то:	CHAIR AND MEMBERS PLANNING AND ENVIRONMENT COMMITTEE
FROM:	GEORGE KOTSIFAS, P.ENG. MANAGING DIRECTOR, DEVELOPMENT & COMPLIANCE SERVICES AND CHIEF BUILDING OFFICIAL
SUBJECT:	APPLICATION BY: SIFTON PROPERTIES LIMITED 555 SUNNINGDALE ROAD EAST PUBLIC PARTICIPATION MEETING ON MONDAY AUGUST 24, 2015 NOT BEFORE 4:30 PM

That, on the recommendation of the Senior Planner, Development Services, the following actions be taken with respect to the Vacant Land Plan of Condominium application of Sifton Properties Limited relating to the property located at 555 Sunningdale Road East:

The purpose and effect of this recommendation is to hold a public meeting for a plan of vacant land condominium at 555 Sunningdale Road East, consisting of 30 townhouse cluster housing units, with the common element area to include a private roadway.

Site Plan

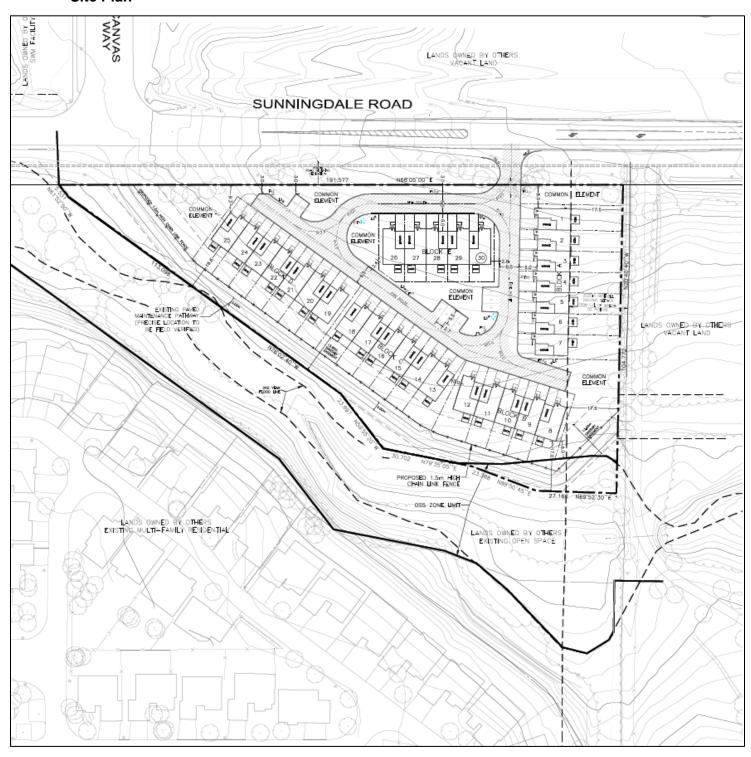
- Left and Right turn lanes will be required to access the site and external works drawing(s) are to be provided for review through Site Plan Approval. The design of external works drawings shall include Pavement Marking drawing(s).
- The site shall match ultimate grades as established through the Sunningdale Road EA.
- The requirement for a working/construction easement along the frontage, as outlined in the Sunningdale Rd EA, is to be shown on the site plan.

- The sanitary outlet for this site is the 375mm sewer located within the existing easement along the south limit of the site with City records indicating an existing 200mm private drain connection is available to the rear of proposed Units 12 & 13.
- In conjunction with this development, the sanitary sewer maintenance road/path shall be reconstructed to its ultimate profile (to match the ultimate Sunningdale Road) as much as possible while maintaining an interim connection to the existing Sunningdale Road profile that is in accordance with City standards (max slopes, etc.).

- Stormwater management for this site is required to comply with the SWM criteria and environmental targets identified in the Stoney Creek Study.
- Based on the steep slopes at the back of the site, there may be increased potential for erosion where stormwater flows are concentrated (i.e. OLE); please investigate the flow velocities/erosion potential and implement energy dissipation and erosion control where necessary.

- Please confirm the flow depth of the overland flow (OLE) and ensure adequate freeboard above the OLF for building openings and ground elevations at buildings.

- UTRCA Approval is required for the storm sewer outlet directly to the flood plain.
- The City's maximum allowable slope is 33% (3:1) in landscaped areas and 5% in internal driveways; please revise accordingly.

- The Owner is to contact Imperial Oil Ltd. at least 48 hours prior to any works occurring within the 20 m Imperial Oil buffer; please indicate this on the engineering plans as well.

- A 3 metre wide multi-use asphalt pathway is located along the south portion of the property through a multi-purpose easement ER553111 registered with the City of London and Sifton Properties on July 5th, 2007. The applicant has indicated chain link fencing to be located north of the existing multi-use pathway. The installation of fencing is up to the owner, however, if fencing is to be installed it should be consistent with the parks standard fence, SPO4.8 or an approved alternative.
- Monuments in place of fencing could be considered.
- Parkland dedication has been provided for this site.

- Provide walkways throughout the site to allow pedestrians to safely access Sunningdale Rd. E.
- Acknowledging that there are currently no sidewalks, a walkway should be adjacent
 to the vehicle entrance and connected to the existing sidewalk to the east, at a
 minimum. The preference would be for sidewalks to be constructed to fill in the
 sidewalk as a temporary measure until the full road reconstruction.

- The side elevations of units 1 and 25, facing Sunningdale Rd. E. should include the same level of detail and interest as the front facades to create an attractive view as seen by pedestrian and vehicular traffic from the public street.

- It is the preference of Urban Design staff that any fencing along the access easement south of the property is decorative, rod-style fencing to allow for passive surveillance of the public pathway system and a high quality aesthetic. Parks Planning has committed to paying for the cost of half of a chain-link fence, and the cost of upgrading would be the responsibility of the developer.

- The UTRCA recently commented on site plan application SP15-00553 wherein we noted that the plan showed Unit 8 as well as fencing encroaching into the hazard/OS5 lands. It appears that the circulated draft condominium plan shows a similar configuration.
- The UTRCA requires that the development be reconfigured so that it is not encroaching into the hazard lands. Based on discussions with City Planning Staff we understand that the entire length of the property along the pathway and hazard lands is being revised to avoid this encroachment. We also understand that retaining walls are going to be incorporated into the development to help reduce the amount of slopes steeper than 3:1.
- The UTRCA requests that this application be deferred until we have an opportunity to review the revised plan for this development.

Staff Response: The UTRCA had concerns with the location of some of the units encroaching into the hazard/OS5 lands and asked for a deferral of the application. Since this comment, the Applicant has provided a revised site plan which shows Unit 8 and the retaining wall/fencing located outside of the OS5 Zone. The revised site plan was circulated to the UTRCA but no formal comments have yet been received. This issue will be addressed prior to issuing site plan approval and prior to the draft approval of the Vacant Land Condominium. A Section 28 permit is required as part of the building permit process.
